City of Issaquah
Major Development Review Team (MDRT)
Administrative Site Development Permit

NOTICE OF DECISION

SUBJECT: Administrative Site Development Permit for Block 24, Lot 1, Issaquah Highlands

Number: ASDP11-00004

SHEET NO
L-101

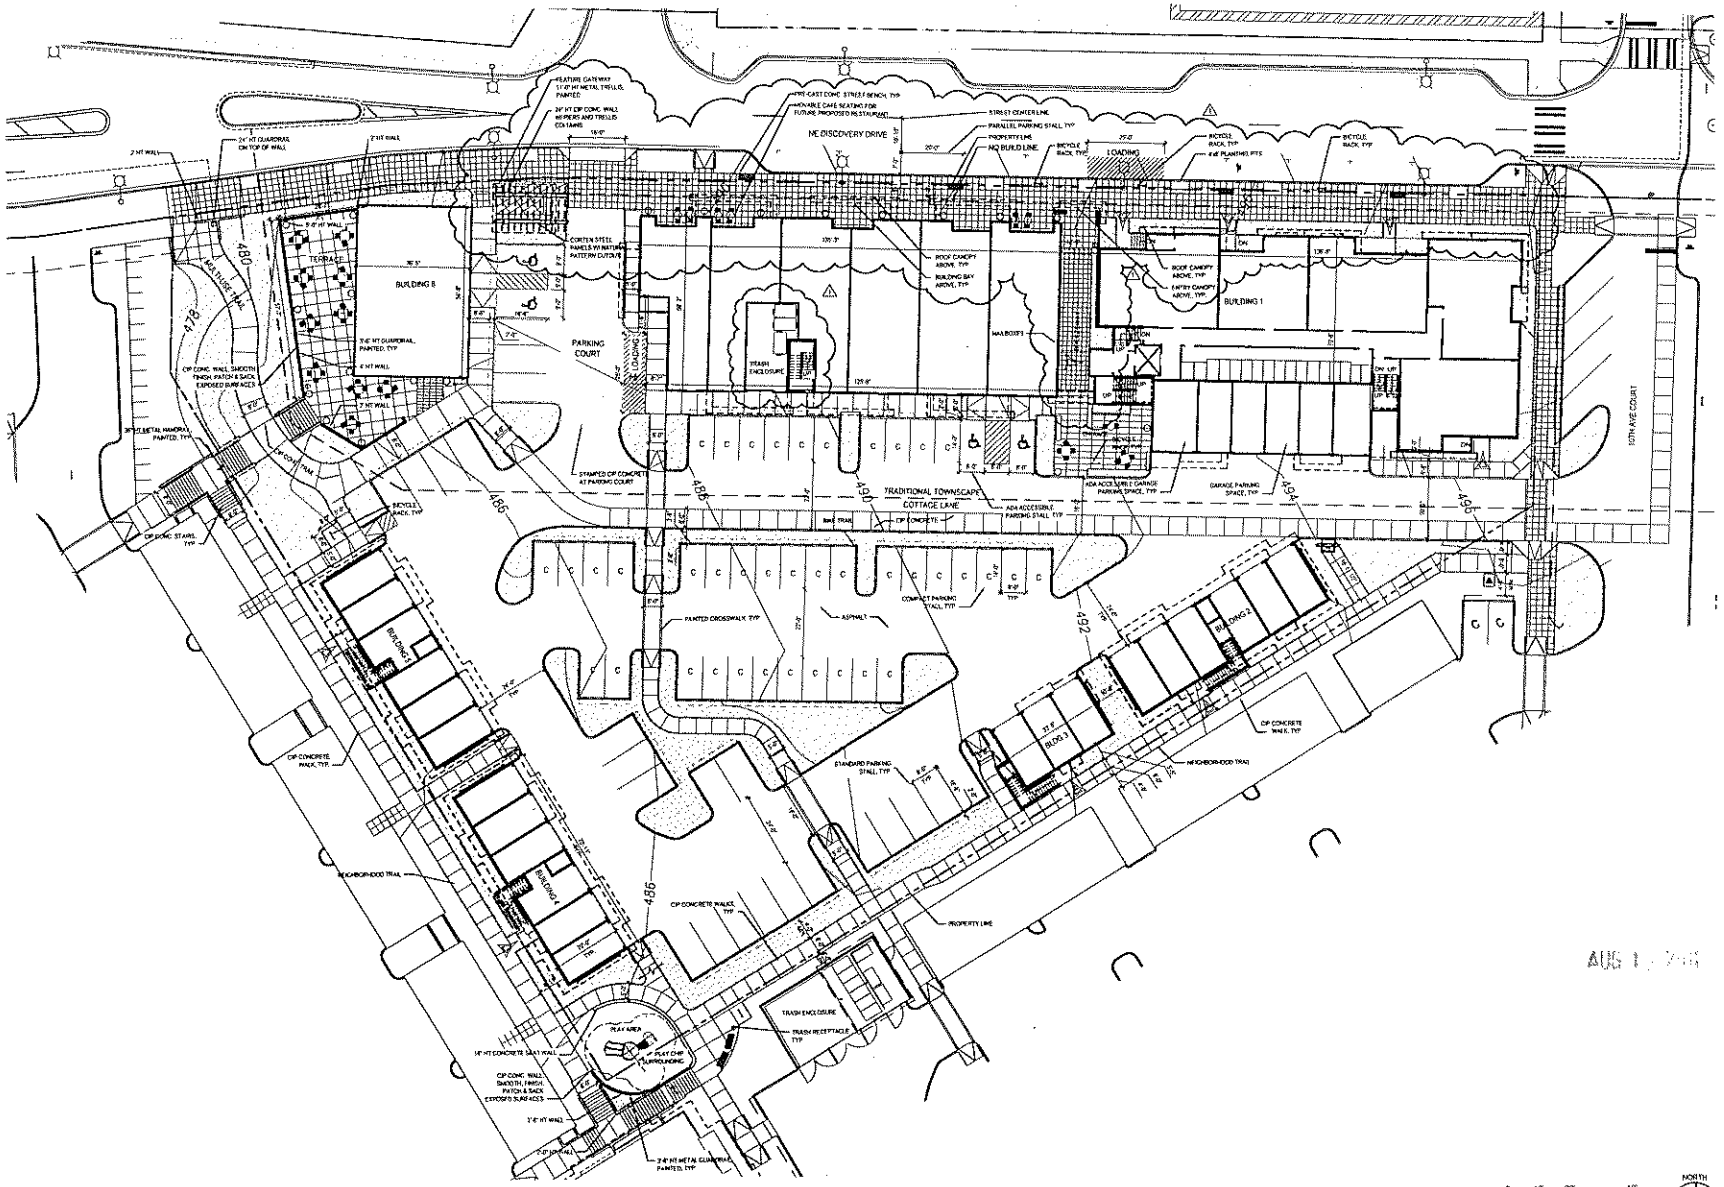
51. Relocate utility vaults shown adjacent to the bike path to less prominent locations away from the bike and north/south trail, such as other beds within the parking lot (east of Bldg 5 and northwest of Bldg 3).

Compact: 39 stalls are designed as compact, which is less than the 50% allowed. Per Appendix O, Section 4.3 parking spaces which are closest to the building's entrances are not compact parking; however, the proposed site plan places compact stalls closest to building entrances. This must be reversed.

- The plaza shown south of Building 1 is south facing and could provide a pleasant opportunity for outdoor space units that do not have, consistent with the expectations of the Multi-family Overlay guidelines. However right now, there is not sufficient screening from the parking lot to create such a pleasant space. The requirements would be for a minimum 3ft tall and wide hedge. It could provide sufficient screening depending on its design. Also the guidelines discourage inappropriate view terminations.

30. The non-residential portions of Buildings 1 and 6 shall not be set back from the sidewalk (or perceived to be setback from the sidewalk), and the entrances to the business must be from the Discovery Drive side of the building.

34. Place standard size stalls closest to building entrances.
